June 13, 2022
Project No. 403215002

Subject: Response to City of Santa Cruz Comments
Proposed Office/Residential Building
2035 North Pacific Avenue
Santa Cruz, California

2035 N. PACIFIC AVENUE FIGURE 5 - TEMPORARY CONDITION

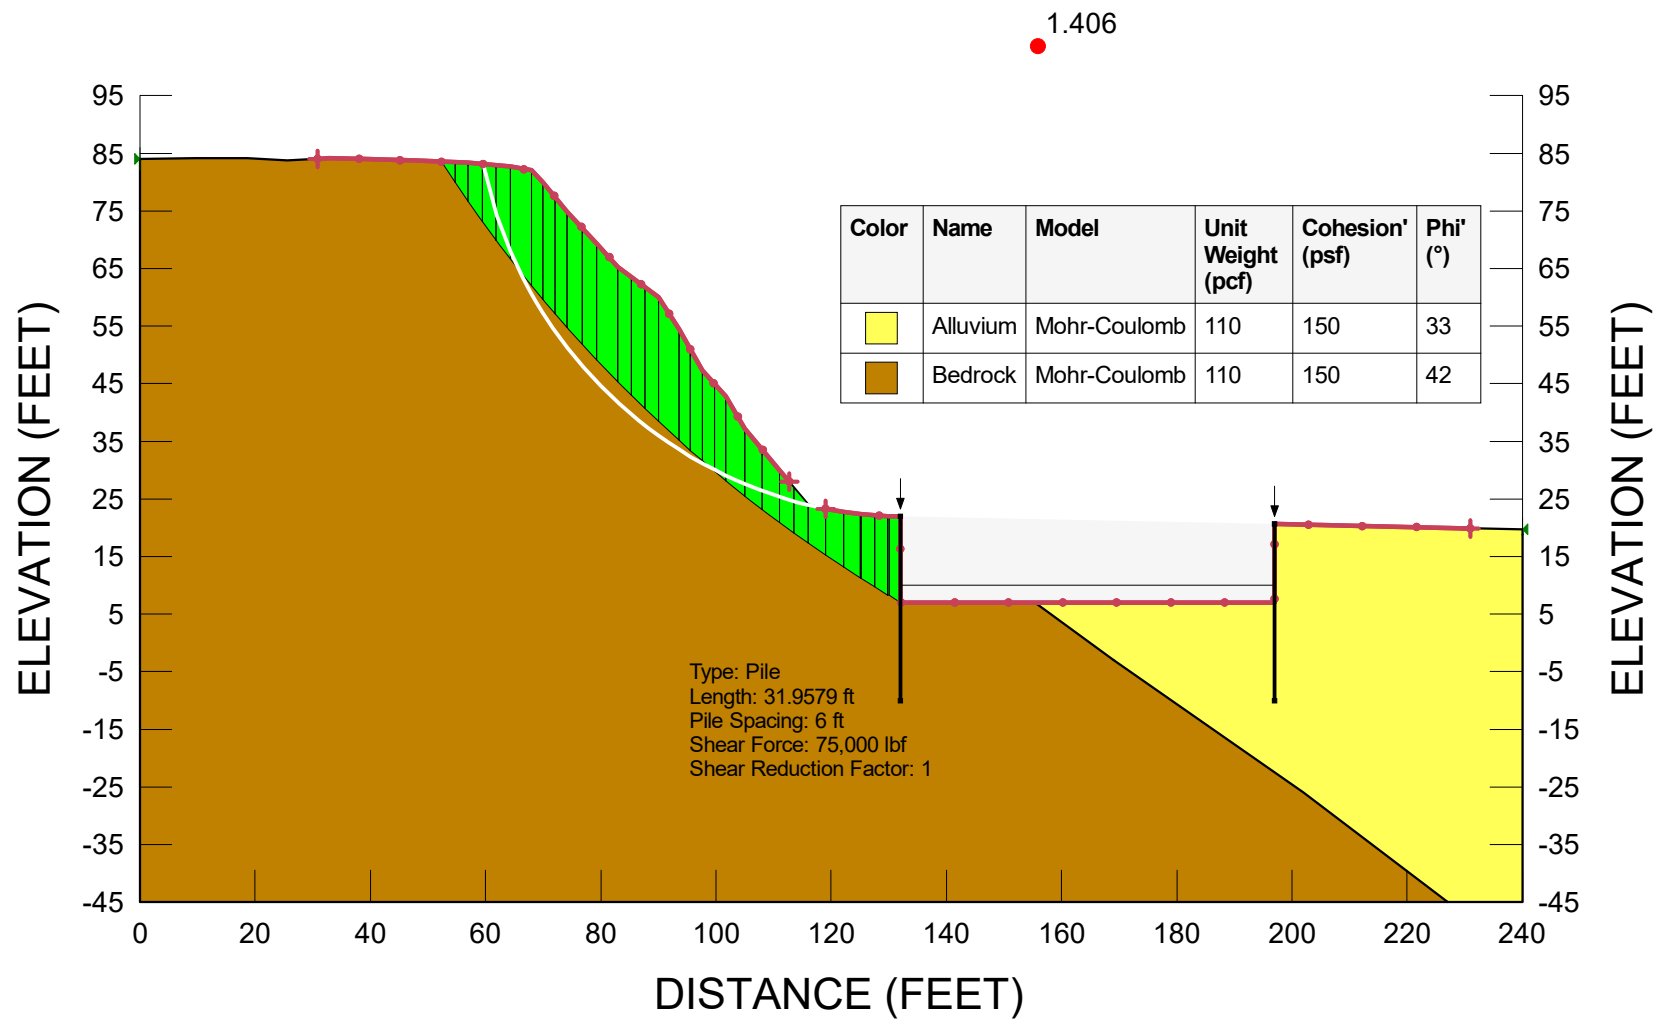
Item 3 – Stability of Ascending Natural Slope and Below-Grade Parking Excavation

The ascending natural slope along the western side of the property is approximately 65 feet high and steeply inclined with residential properties along the top (Figure 2). The western side of the excavation for the proposed below-grade parking area will be about 10 feet away from the property line and close to the toe of the slope. Slope stability analyses were performed using the two-dimensional stability analysis program SLOPE/W modeling the long term (with proposed below-grade parking area in place) and temporary (i.e., during removal of the buried tank foundation) conditions in order to evaluate the impact of the proposed site improvements on the westerly ascending slope. Strength parameters used in our stability analyses were based on laboratory testing performed during our 2018 geotechnical evaluation (Ninyo & Moore, 2018). The results of the slope stability analyses indicate that the westerly ascending slope will have a factor of safety of 1.5 or higher in the long run when soldier piles are incorporated into the shoring design (Figure 4). Furthermore, the westerly ascending slope will have a factor of safety of about 1.4 (Figure 5) during the temporary condition (i.e., during removal of the buried tank foundation) incorporating soldier piles into the shoring. The factors of safety presented here indicate that the stability of the subject slope under long-term and temporary conditions will be acceptable and in conformance with the standard of care currently exercised in geotechnical engineering practice.
